Re: City of Kingsville – City of Kingsville Landfill
 Kingsville, Kleberg County, Texas
 Municipal Solid Waste Permit Number 235C
 RN102334570/CN600674246
 Type I & Type IV Permit Major Amendment Application

On behalf of the City of Kingsville and in response to the October 3, 2018 Administrative Notice of Deficiency Letter, we hereby submit the enclosed response regarding the Permit Amendment Application for the above referenced MSW facility. For your convenience, we have included your comments from the October 3, 2018 letter (in italics and numbered according to the Application Deficiencies – Administrative NOD #1 table provided as an attachment to the October 3, 2018 letter) followed by the corresponding responses. Where items from the original application have been noted as revised, a redline/strikeout version clearly identifying all proposed changes from the existing application (if possible) and a replacement copy ('clean copy') of the applicable section or attachment has been attached to this response to allow you to substitute the items in the binders for the originally submitted application.

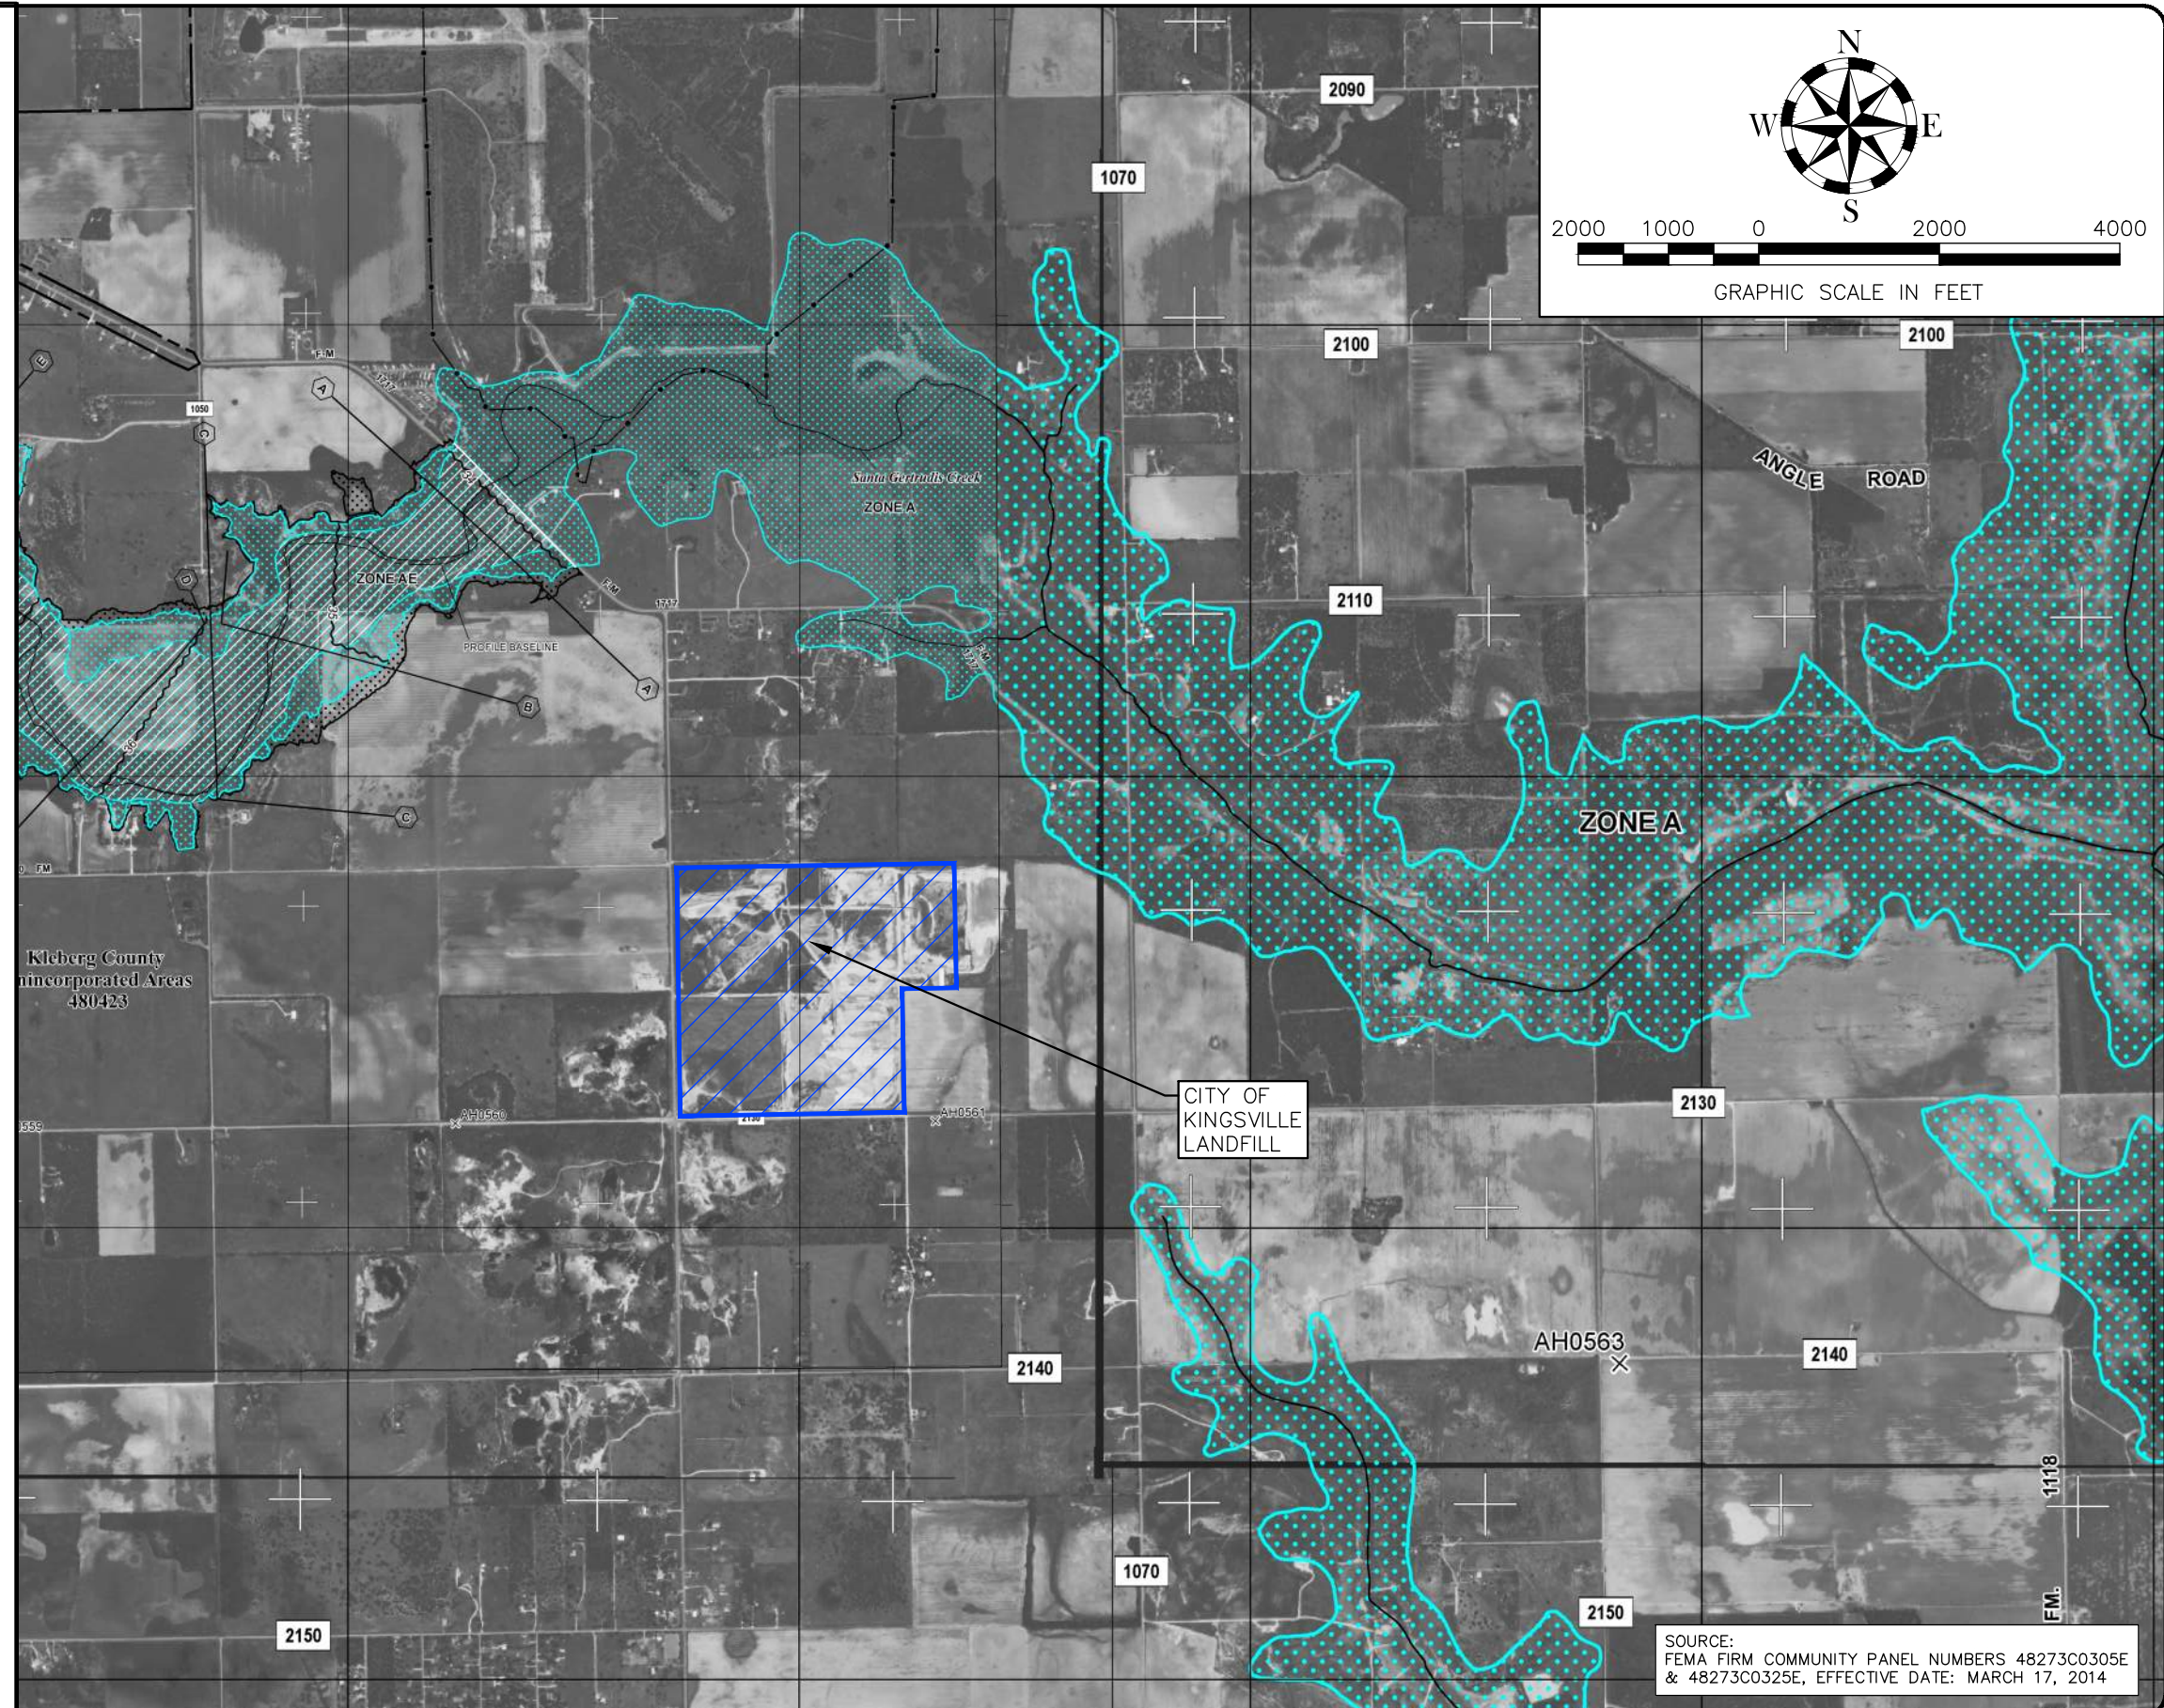
ID	App. Part	App. Section	Location	Citation	Error Type
A11	II	Part II	Attachment 1		Incorrect
Deficiency Description/Resolution					
Please provide the correct Floodplain Map Figure: II. 1-5.

The Floodplain Map Figure: II.1-5 is provided in Appendix 6 of this submittal.

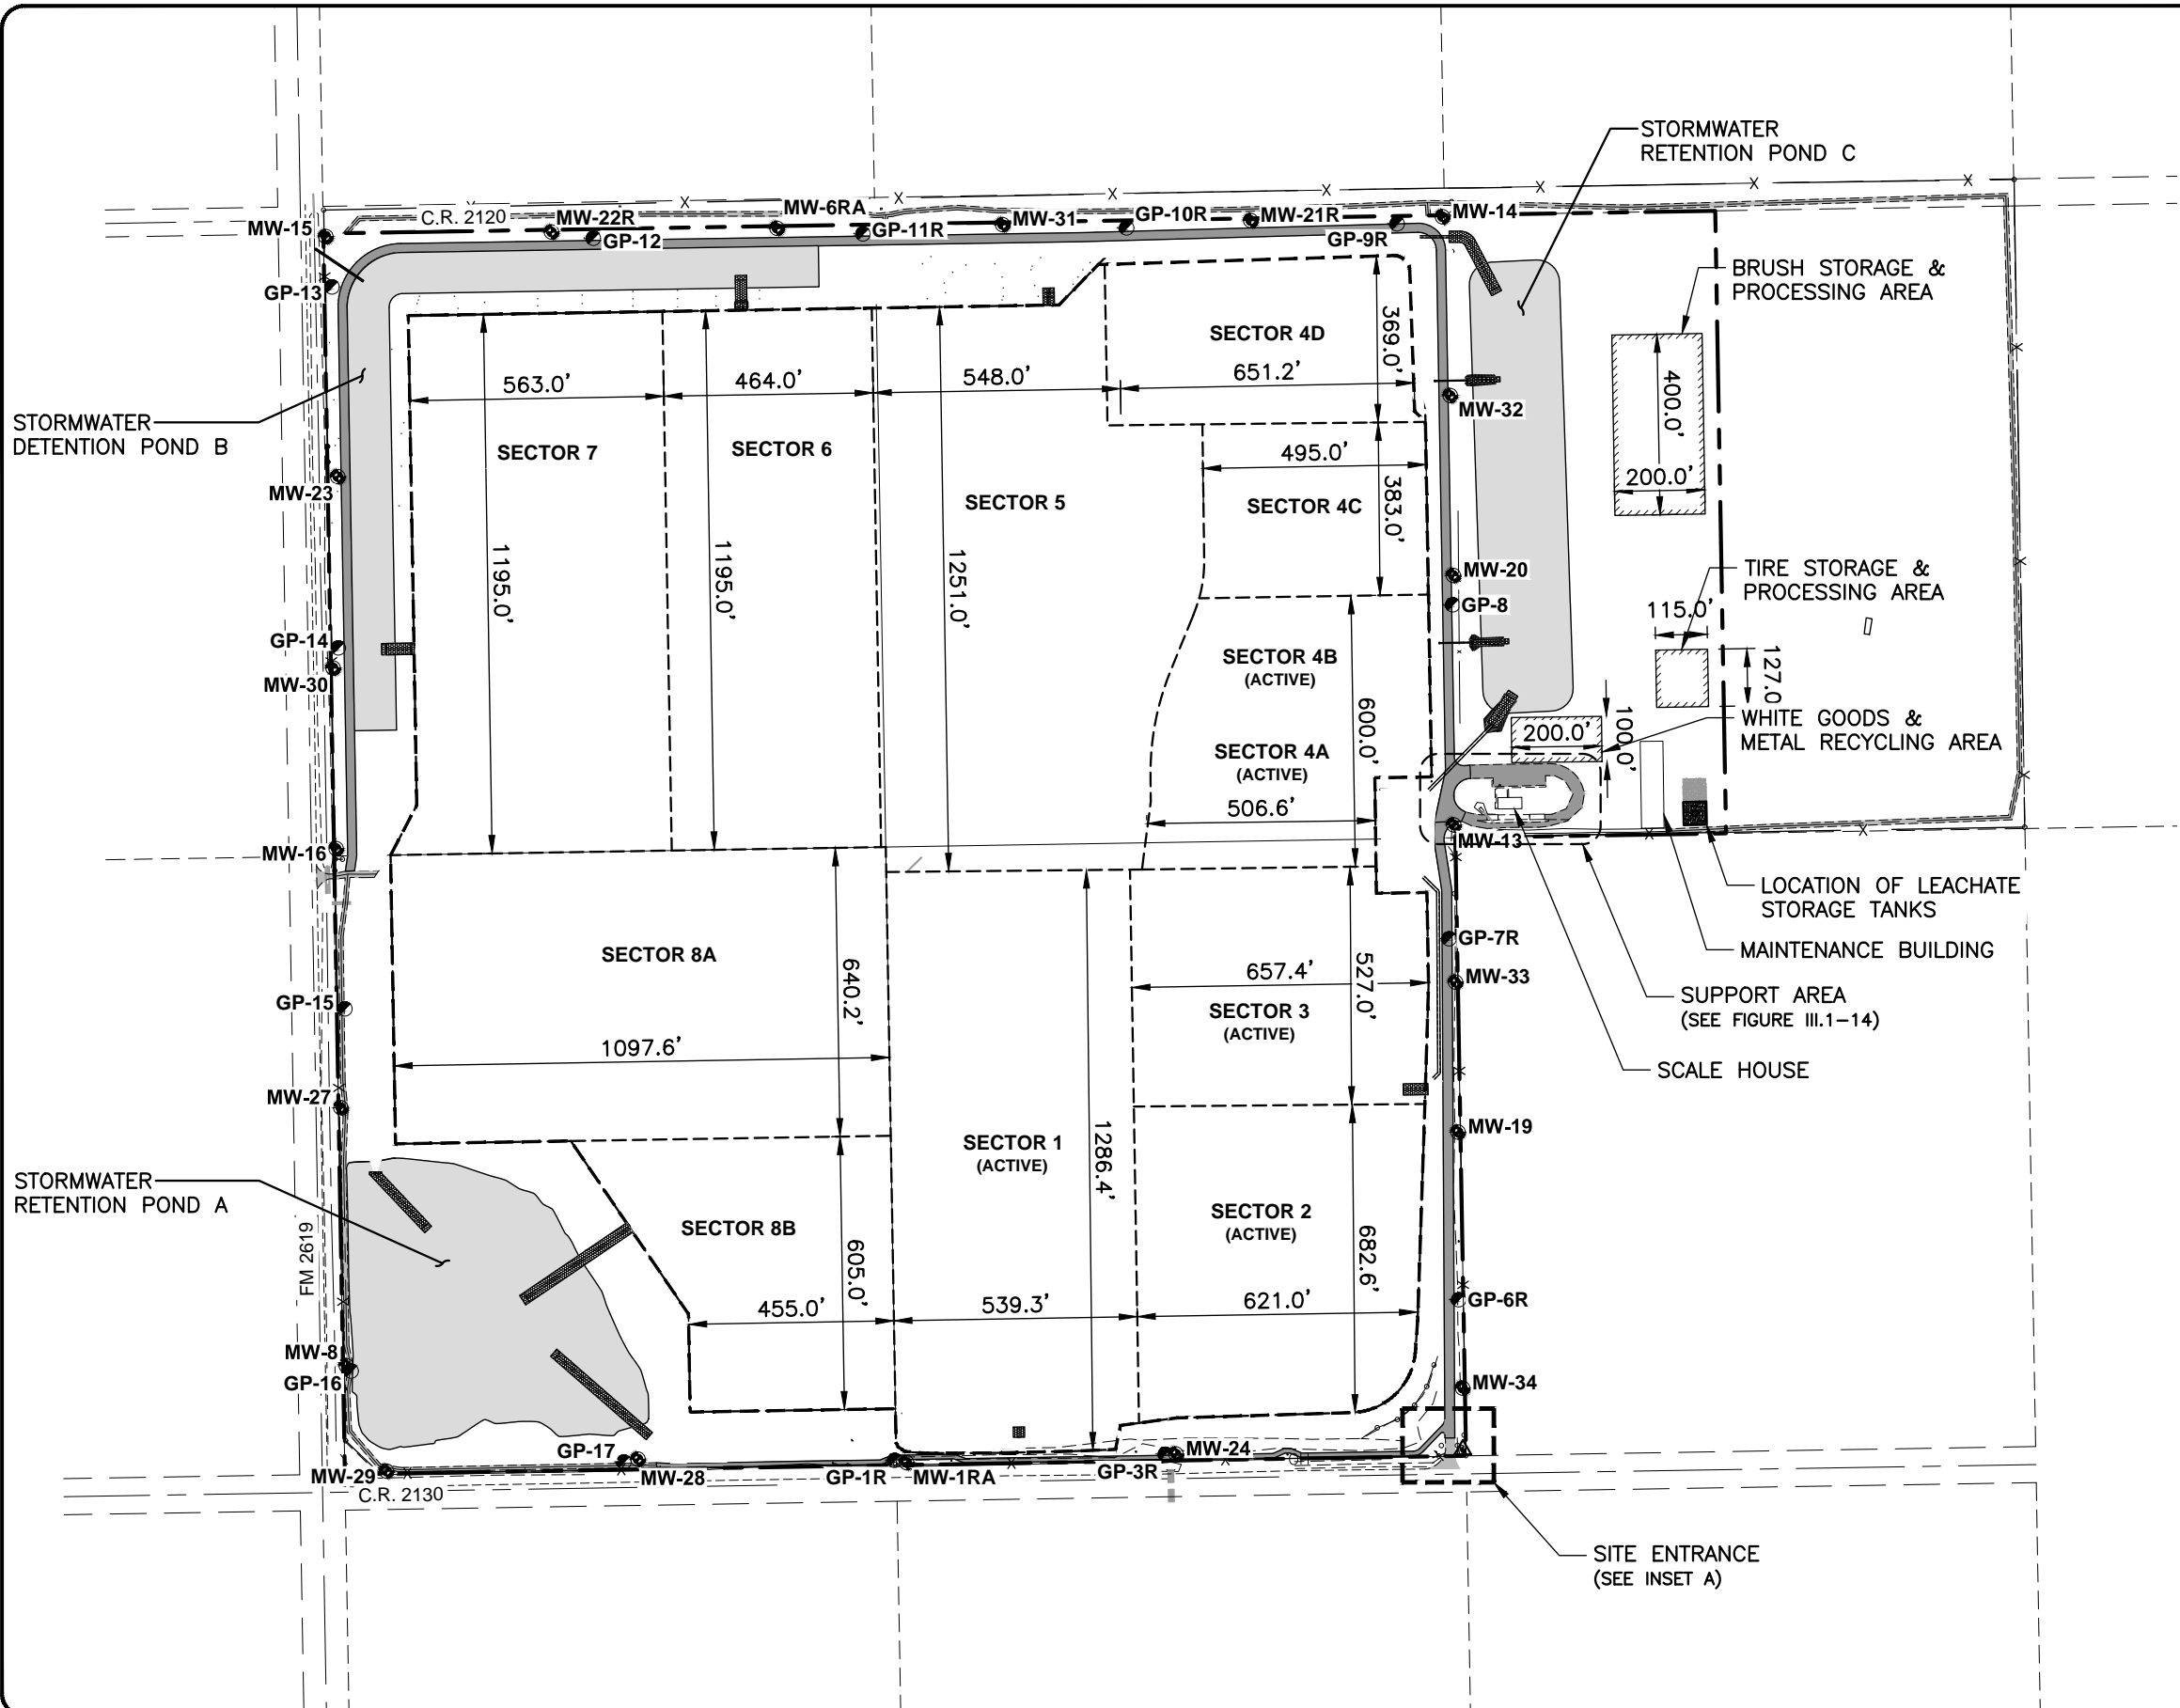
ID	App. Part	App. Section	Location	Citation	Error Type
A12	II			330.61(d)	Omitted
Deficiency Description/Resolution					
Please provide Figure I.2-5, the facility layout map, it is not included in Part I, Attachment 2.

The Facility Layout Map Figure I.2-5 is provided in Appendix 7 of this submittal.
